22 TRAFFIC

22.1 EFFECTS OF ROAD TRAFFIC ON MAJOR PUBLIC ROADS

Figure 22.1 Heavy vehicle trips: Princes Highway

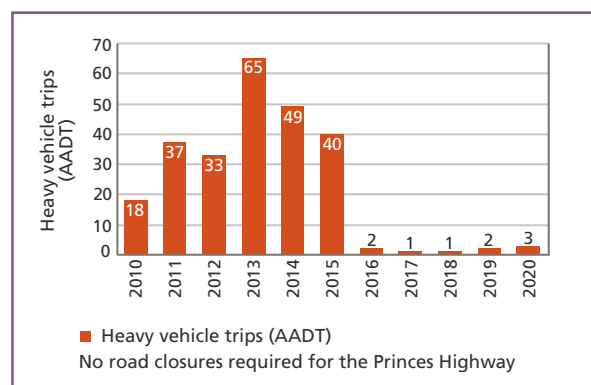
Clarification was sought on the impact of the proposed expansion-related traffic, and the impact on the Princes Highway traffic south of Port Augusta.

Figure 14 in Appendix Q9 (Section 3.2.2) of the Draft EIS, reproduced in the Supplementary EIS as Figure 22.1, summarises total construction and operational heavy vehicle movements associated with the expansion of Olympic Dam from 2010 to 2020, including over-dimensional loads, on the Princes Highway (south of Port Augusta at Two Wells, near Adelaide). A summary of the origin of heavy vehicle movements associated with the expansion of Olympic Dam five and 10 years after commencement of the expansion project was also contained in Appendix D of the TIA.

Calculations based on two-way traffic movements in the peak transport period, approximately five years after the expansion project began, found that the project would reduce overall vehicle traffic, including heavy vehicle movements, on the Princes Highway near Two Wells. This is the consequence of barging prefabricated material to the landing site and maximising rail transport to the Pimba intermodal facility. The study also assessed the effects of changes in traffic flows and found that the Princes Highway would continue to operate at level of service (LoS) 'A' (free-flowing) during these years.

Figure 22.2 Key components of the proposed expansion at Olympic Dam for the traffic assessment

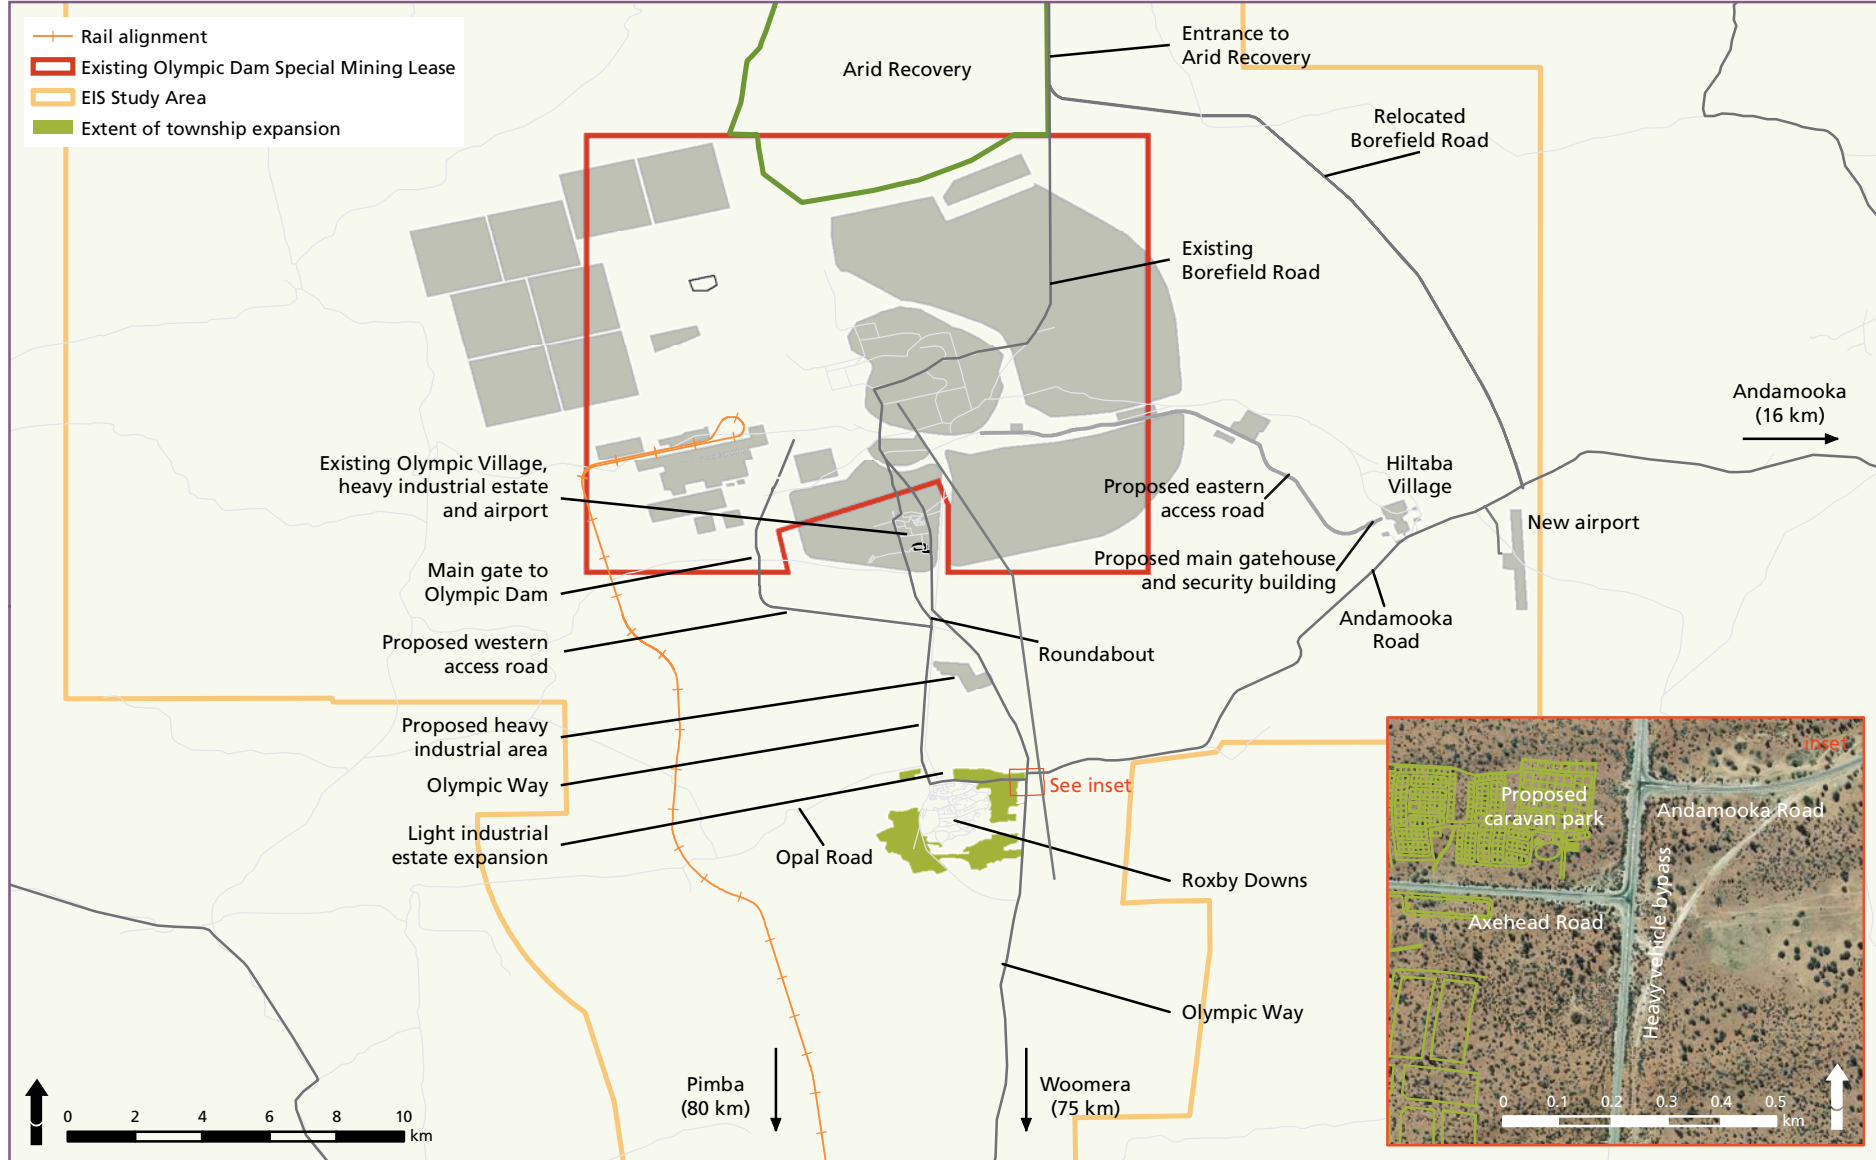
The increased traffic generation as a result of the proposed expansion has raised a number of traffic-related issues in the immediate surrounds of Roxby Downs, in particular:

- traffic volumes associated with the new airport and heavy industrial area
- traffic disruption on Olympic Way as a result of the newly proposed roundabout
- maintenance of existing roads

The only proposed road change on Olympic Way would be the installation of a roundabout at the intersection of the Roxby Downs–Pimba Road (Roxby Heavy Vehicle Bypass) (see Figure 22.2). The intersection would be required for the new western entry road to Olympic Dam and to enable traffic flow to continue along Olympic Way to Olympic Village, the existing industrial estate, Laverick’s roadhouse, the Olympic Dam Sports Club and the existing airport. BHP Billiton would produce a proposed design for the roundabout that complied with Australian road design standards and work with DTEI and the Roxby Downs Council to ensure the design allowed for future road network developments that may be considered.

The introduction of the roundabout is not anticipated to affect traffic flow along Olympic Way, as the design would incorporate suitable slip lanes to accommodate turning traffic. With the introduction of the second new entry gate and eastern access road, expansion-related traffic would reduce along Olympic Way compared to the predicted traffic flows presented in the Draft EIS (see Appendix A6 for details). The TIA presented in the Draft EIS noted a reduction to the level of service (LoS) on the northern section of Olympic Way. The addition of the eastern access road would have the affect of reducing traffic volumes of Olympic Way and retaining the existing LoS.
